FORM APPROVED
OMB NO. 1004-0137
Expires: January 31, 2018**SUNDRY NOTICES AND REPORTS ON WELLS**
Do not use this form for proposals to drill or to re-enter an
abandoned well. Use form 3160-3 (APD) for such proposals.5. Lease Serial No.
NMNM03677

8. Well Name and No.
STEBBINS 20 FED 124H9. API Well No.
30-015-4418510. Field and Pool or Exploratory Area
WILDCAT;BONE SPRING

☒ Notice of Intent☐ Subsequent Report☐ Final Abandonment Notice☐ Acidize☐ Alter Casing☐ Casing Repair☐ Change Plans☐ Convert to Injection☐ Deepen☐ Hydraulic Fracturing☐ New Construction☐ Plug and Abandon☐ Plug Back☐ Production (Start/Resume)☐ Reclamation☐ Recomplete☐ Temporarily Abandon☐ Water Disposal☐ Water Shut-Off☐ Well Integrity☒ Other
Change to Original A
PD

Please see attached plats to revise the SHL from 361' FSL & 130' FWL to 331' FSL & 260' FWL. Net move is 133' ESE. Also attached are the updated drill rig layout/H2S diagram, and production facility/interim reclamation diagram.

WELL LOCATION AND ACREAGE DEDICATION PLAT

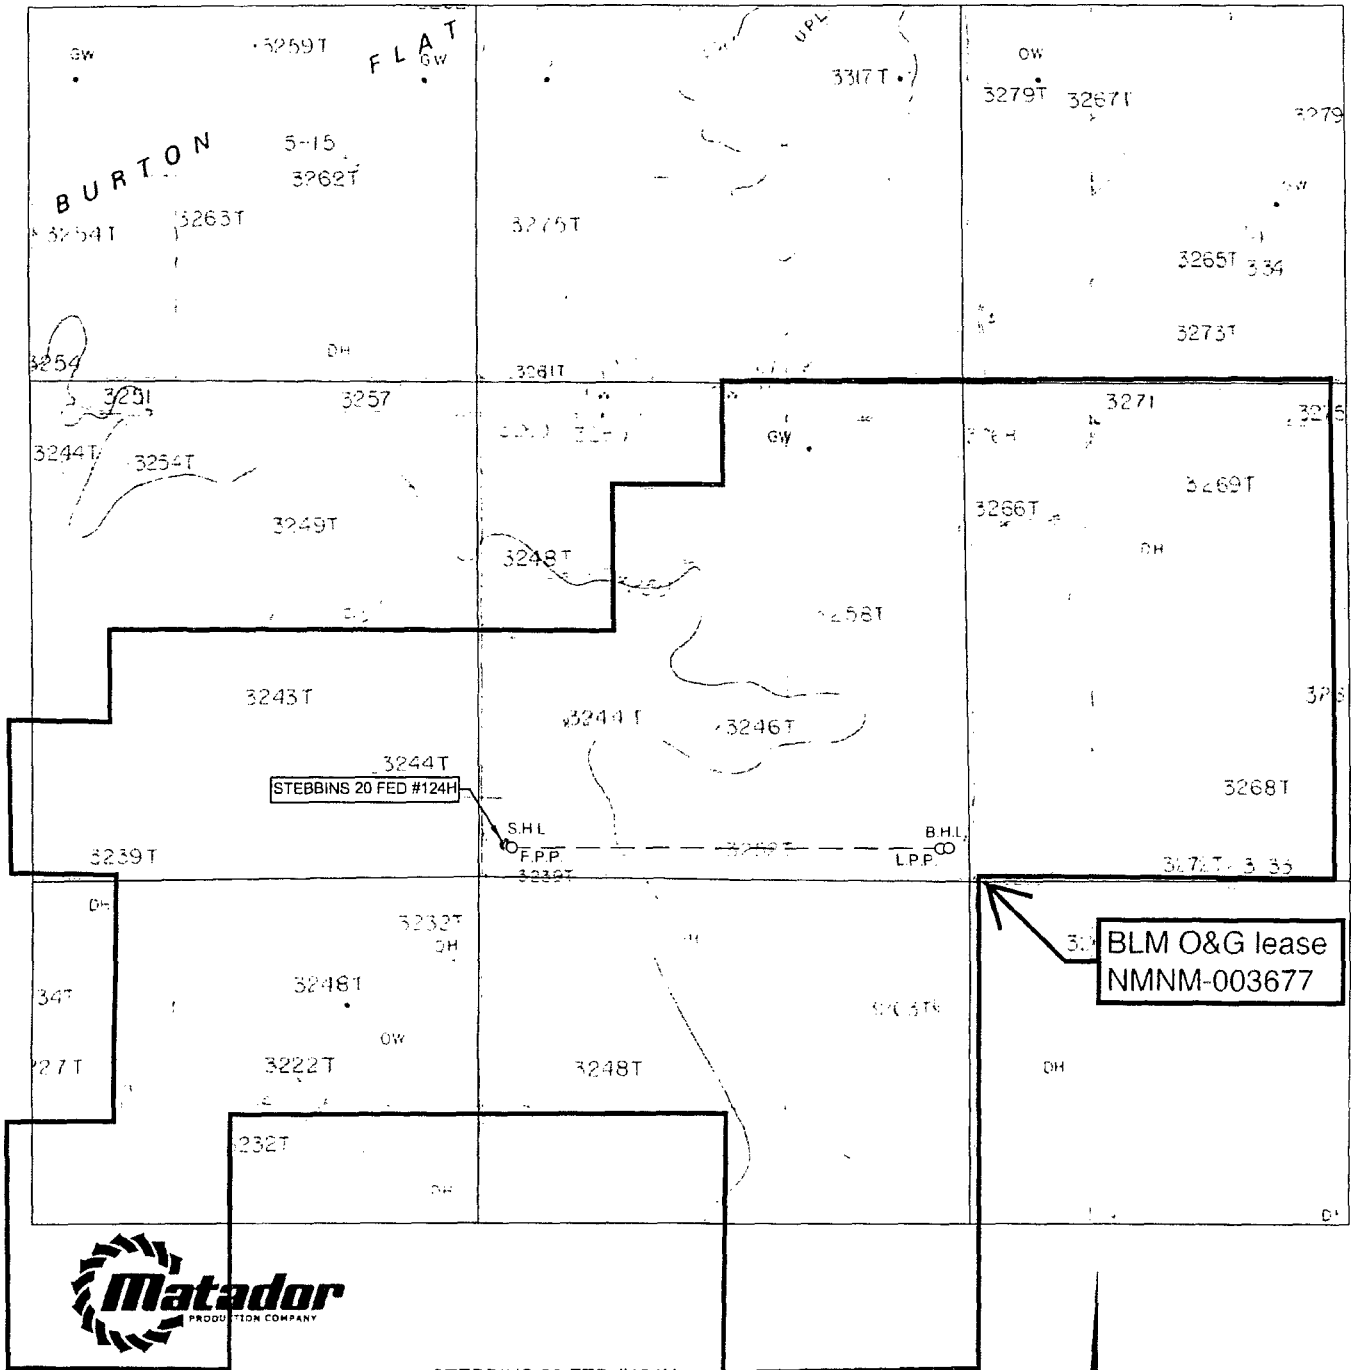
There is no change in pad size or location. SHL has moved within previously approved footprint. There is no change in BHL.

revised Drill Rig & H2S Diagram

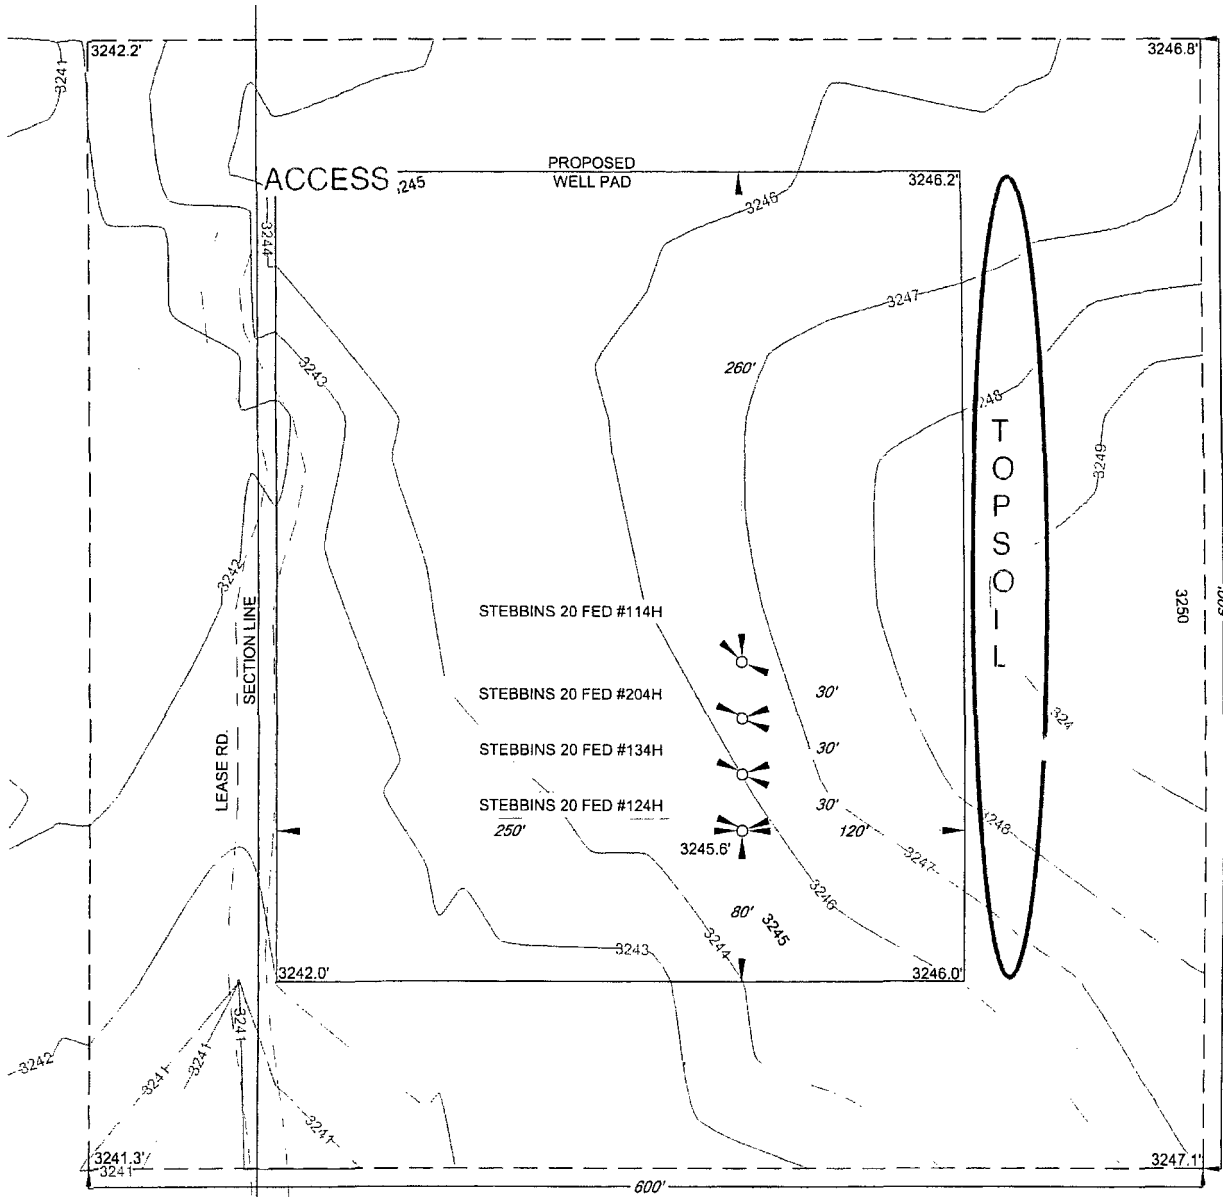
Change in SHL more efficiently uses the pad space, more safely coordinates future operations with the directly adjacent Stebbins 19 Fed slot 4 pad to the west, and revises SHLs to fit Matador's rig. Similar Sundry Notices for the other 3 wells (114H, 134H, & 204H) on this pad.
